District Department of Transportation

C Street NE Rehabilitation Project

Updated 65 Percent Design Technical
Analysis Incorporating Public Feedback

June 2018

Figure 2: April Modifications to February 65% Design—15th Street NE to 16th Street NE

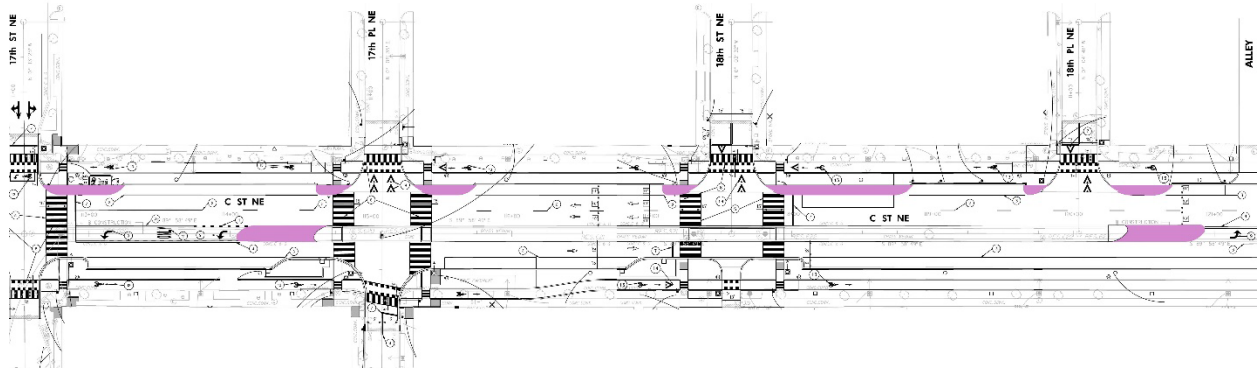
After identifying the issues with the traffic modeling and analysis of the February 65% design, DDOT developed alternative approaches to mitigate traffic impacts while retaining multimodal safety improvements along the C Street NE corridor. These are discussed below and summarized in Table 4. Figures 2, 3, and 4 illustrate the proposed design changes; numbers in the following text correspond to the numbers on the figures. In addition to these alternative scenarios, DDOT considered and rejected further alternatives that had greater benefits for traffic flow but were deemed contrary to the purpose and need for the project. The potential changes were presented at the April 26th public meeting. The April design plan reflected the operational approach in Scenario A, but the flexibility to transition to Scenario B if necessary.

The addition of a dedicated westbound right-turn lane at 19th Street would allow for right-turns to operate under protected-only phasing with no turns on red permitted. Protection would also be provided at 21st Street and 15th Street. This adds another degree of protection for cyclists by removing conflicts with that movement. The February 65% design also contains two unsignalized pedestrian crosswalks at 17th Place (8) and 20th Street (9). Adding signalization to these intersections will provide pedestrians with protection for crossing C Street. Finally, the traffic pattern at 21st Street will be modified to allow dual southbound left turns by separating pedestrian and vehicle traffic.

Figure 4: April Modifications to February 65% Design—19th Street NE to 21st Street NE

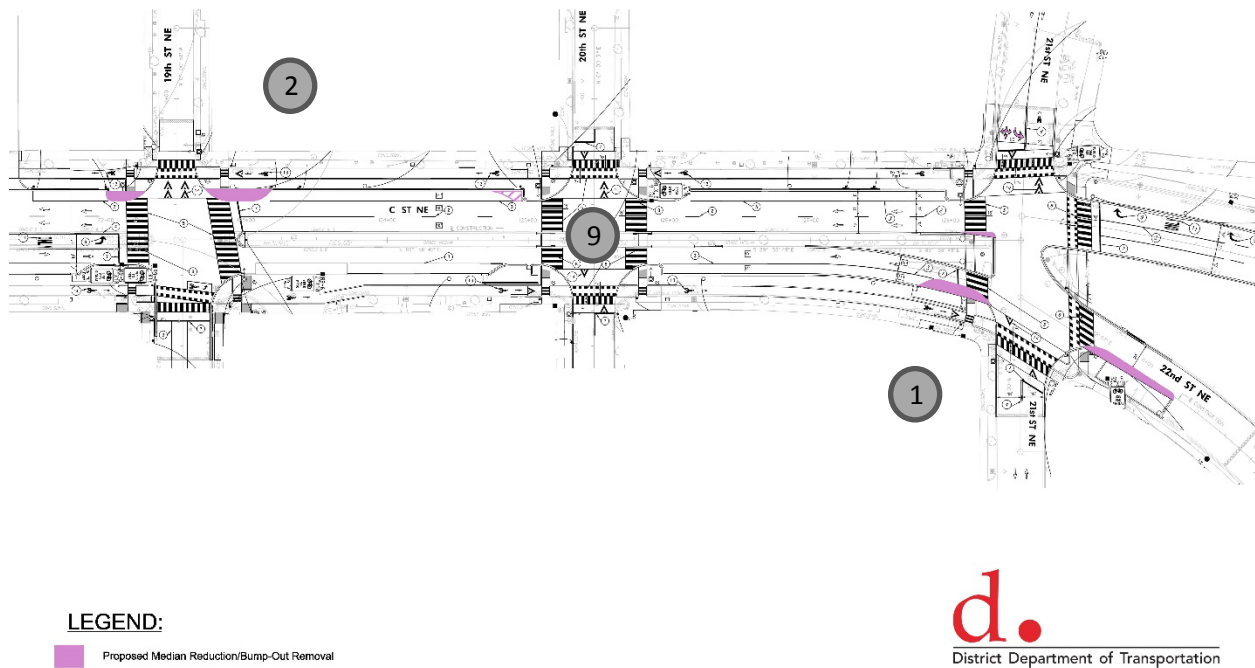
The first alternative seeks to accommodate high turning volumes throughout the corridor and provide greater protection for cyclists and pedestrians. In the eastbound direction, bump-outs would be reduced by approximately 8 feet at the southwest and southeast corners of the C Street and 21st Street (1). This in conjunction with PM parking restrictions will provide two eastbound travel lanes on C Street through the 21st street intersection from 4:00 PM to 6:30 PM. The bump-out on the northeast corner of the C Street and 19th street intersection would be removed and parking restricted in advance of the intersection to create a dedicated right-turn lane and protected bicycle phasing (2). Creation of the

right-turn lane would remove right-turning vehicles from the through traffic flow, increasing the safety for road users by reducing the potential for rear-end collisions and side-swipes and allowing for protected-only turning movements across the cycletrack. Bump-outs would be modified at the northwest and northeast corners of the C Street and 16th Street intersection and parking restricted in advance of the intersection to create a shared through/right-turn lane (3). Bump-outs will remain at all other locations.

The westbound left-turn bay at 17th Street (4) and the eastbound left-turn bay at 19th Street (5) would also be extended to prevent turning vehicles from blocking through traffic. Finally, in order to prevent bus blockages, westbound bus stops at 17th Street (6) and 18th Street (7) would be relocated into the parking lanes. This would prevent bus blockages at these locations and prevent sideswipe and rear-end conflicts between vehicles attempting to pass buses picking up or discharging passengers.

Figure 7: February 65% Design 19th Street Westbound Operations

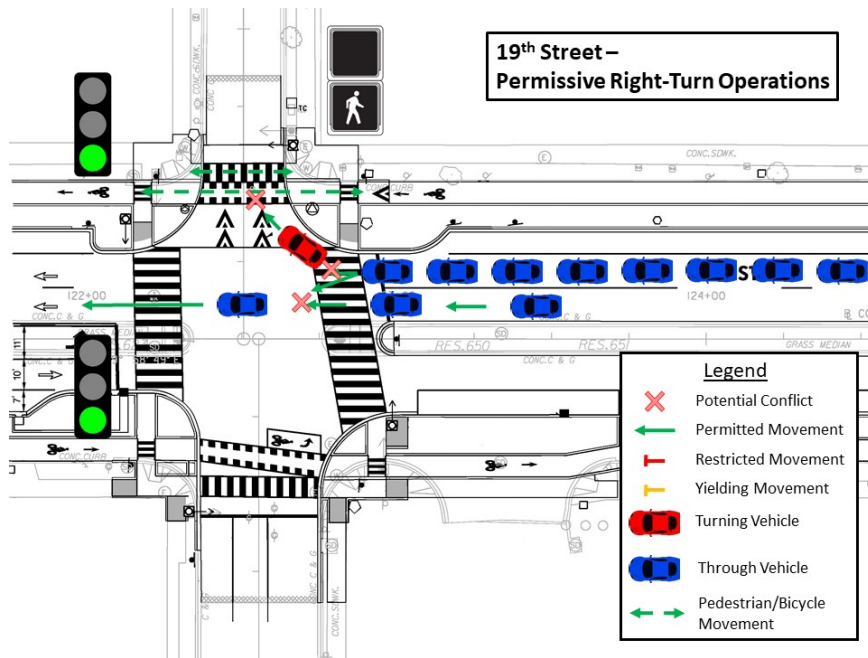
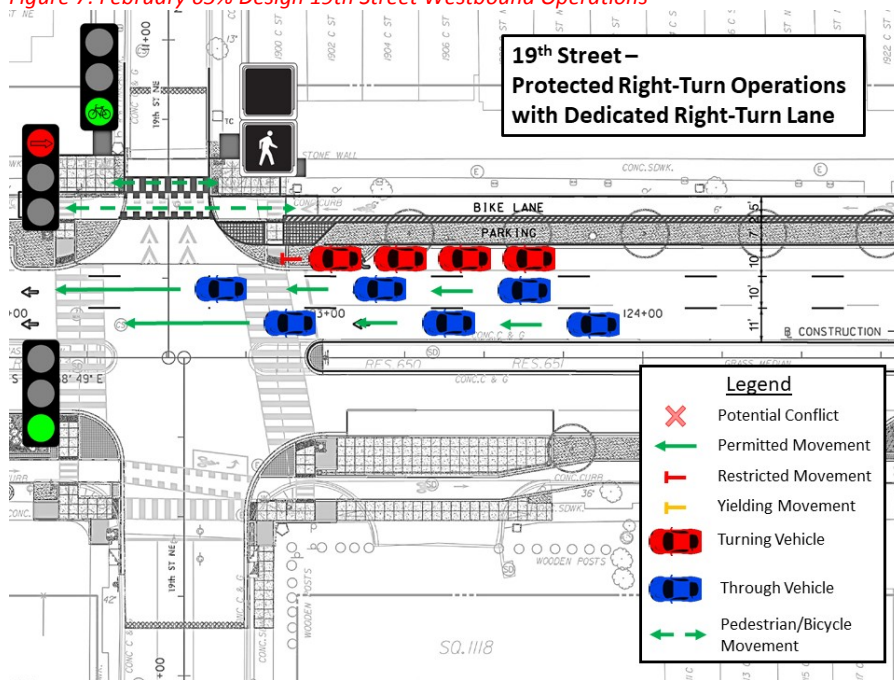
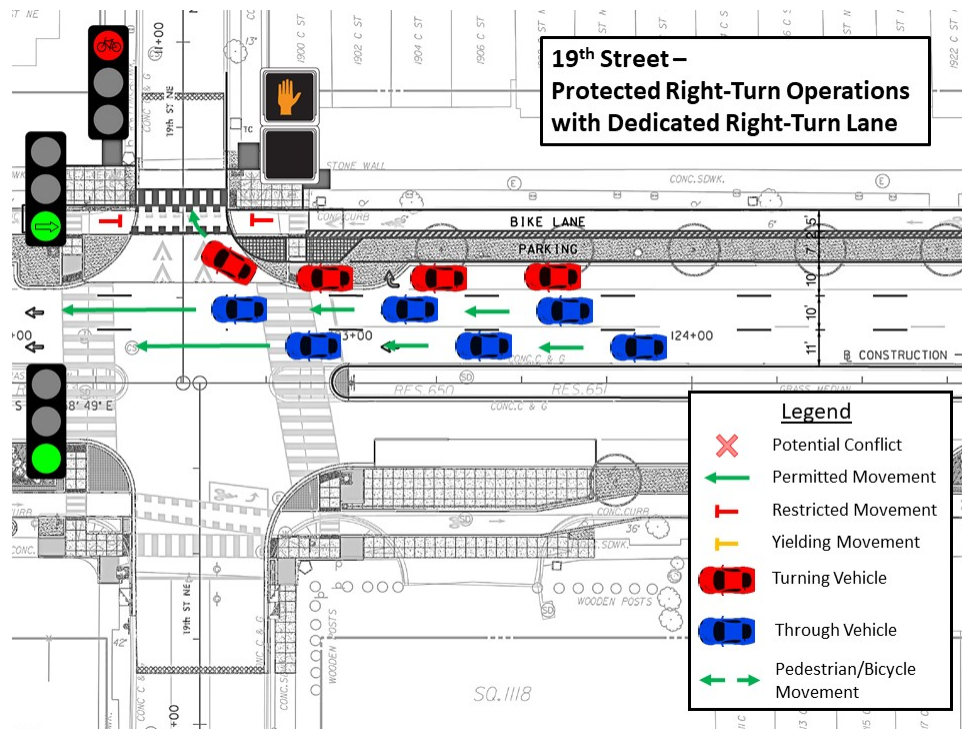
- A westbound right-turn lane will be added at 19th Street during all times of day. This will reduce the near-side westbound bump-out but keep in place the far-side bump-out, preventing vehicles from using it as a through lane. The illustration of this change is depicted in Figures 7, 8, and 9, which are located in Appendix B.

| Location/Direction | | February Design Plans | April Design Plans | June Design Plans |
|-------------------------|-----------|-------------------------------------|---|--|
| 19 th Street | Westbound | 2 through lanes | 2 through lanes + 1 right turn lane near side parking + far side bulb out removed | 2 through lanes + 1 right turn lane near side parking + far side bulb out restored |

Figure 10: 65% Design 17th Street Westbound Operations

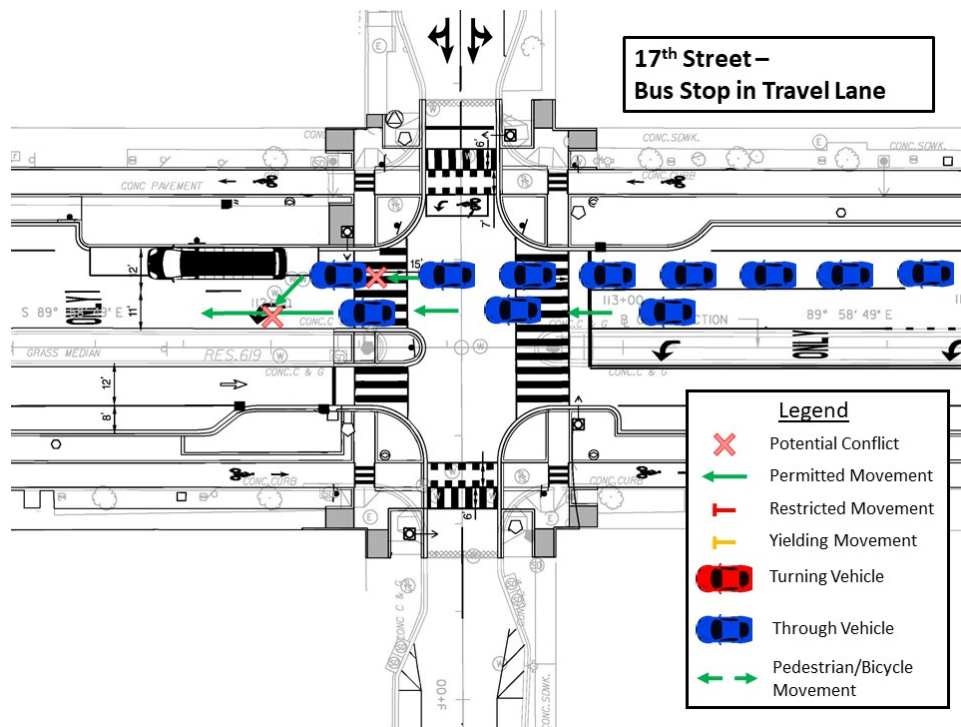
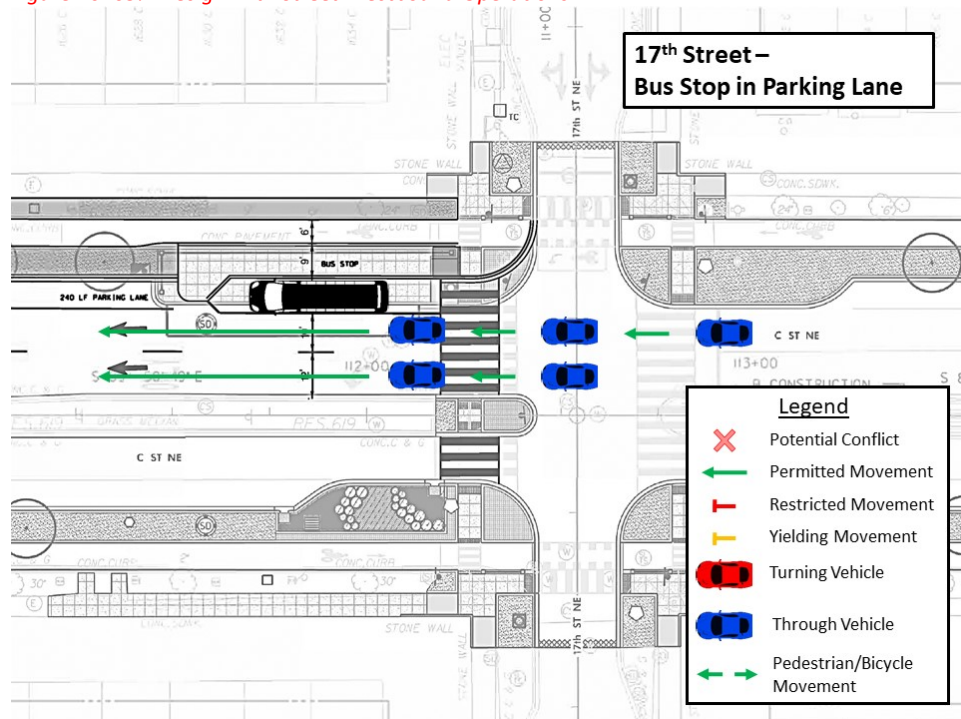
- The far-side bus stop at 17th Street will be moved out of the travel lane. This will reduce the far-side westbound bump-out. The illustration of this change is depicted in Figures 10 and 11, which are located in Appendix B.

| Location/Direction | | February Design Plans | April Design Plans | June Design Plans |
|-------------------------|-----------|-------------------------------------|---|--|
| 17 th Street | Westbound | 2 through lanes + left turn lane | 2 through lanes + left turn lane + bus bulb removed | 2 through lanes + left turn lane + bus bulb removed, near side bulb out restored. |

Figure 12: 65% Design 16th Street Westbound Operations

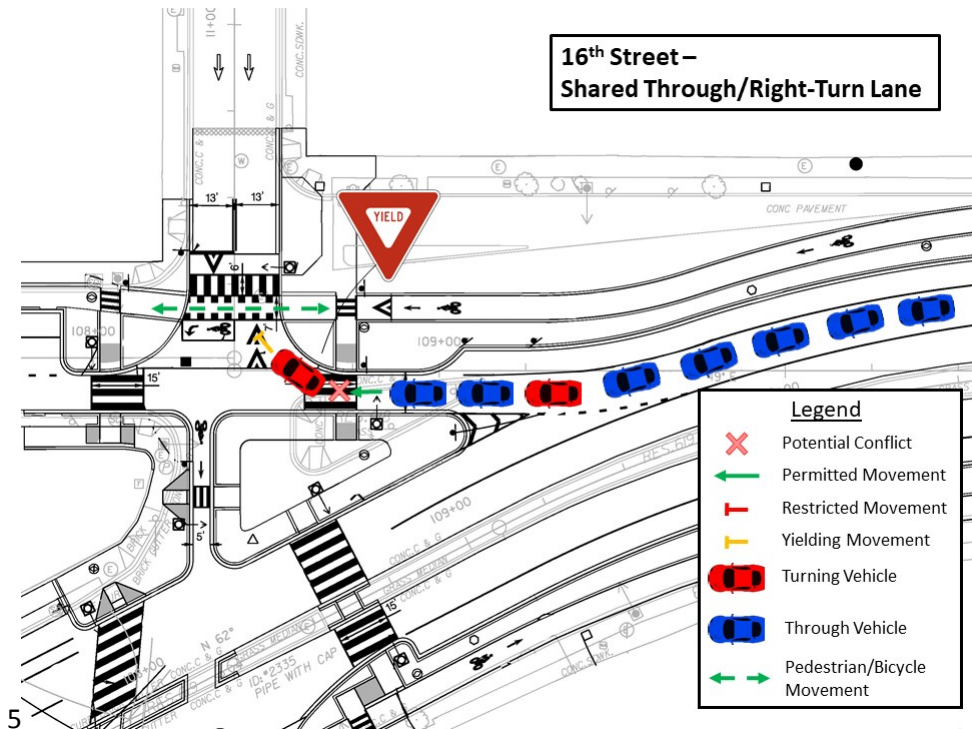
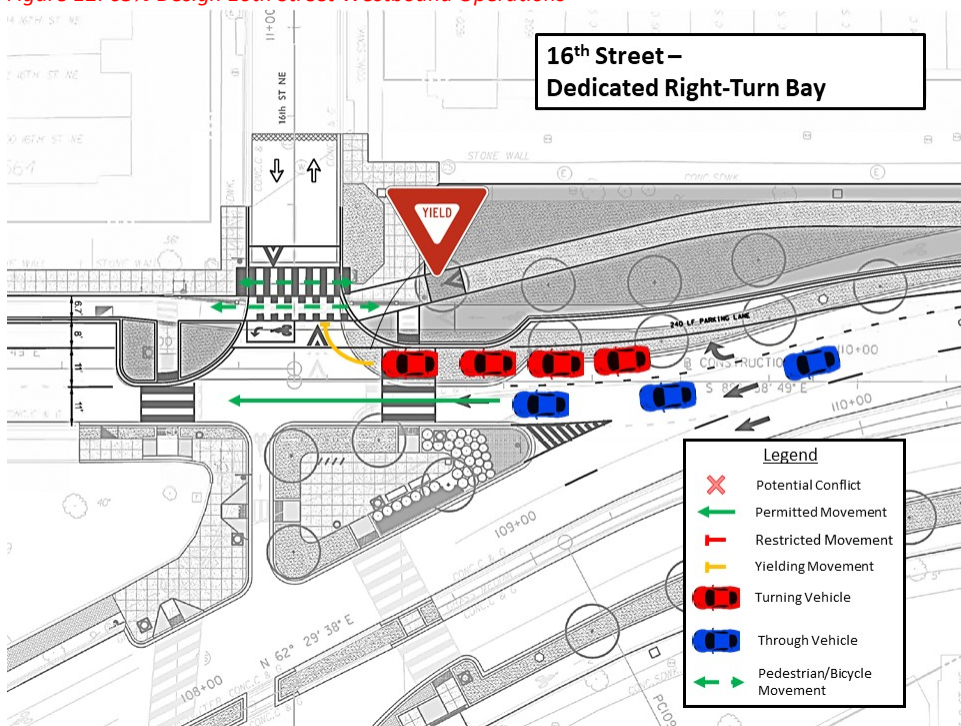
- The intersections of C Street and 20th Street and C Street and 17th Place will be signalized to protect crossing pedestrians.
- A westbound right-turn bay will be added at 16th Street. This will reduce the near-side westbound bump-out but keep in place the far-side bump-out, preventing vehicles from using it as a through lane. Only one lane will be designated for through traffic on C Street at 16th Street. The illustration of this change is depicted in Figures 12 and 13, which are located in Appendix B.

| Location/Direction | | February Design Plans | April Design Plans | June Design Plans |
|-------------------------|-----------|-------------------------------------|---|--|
| 16 th Street | Westbound | 1 through lane | 1 through lane + bulb outs removed + parking removed | 1 through lane + 1 right turn lane + parking restored |
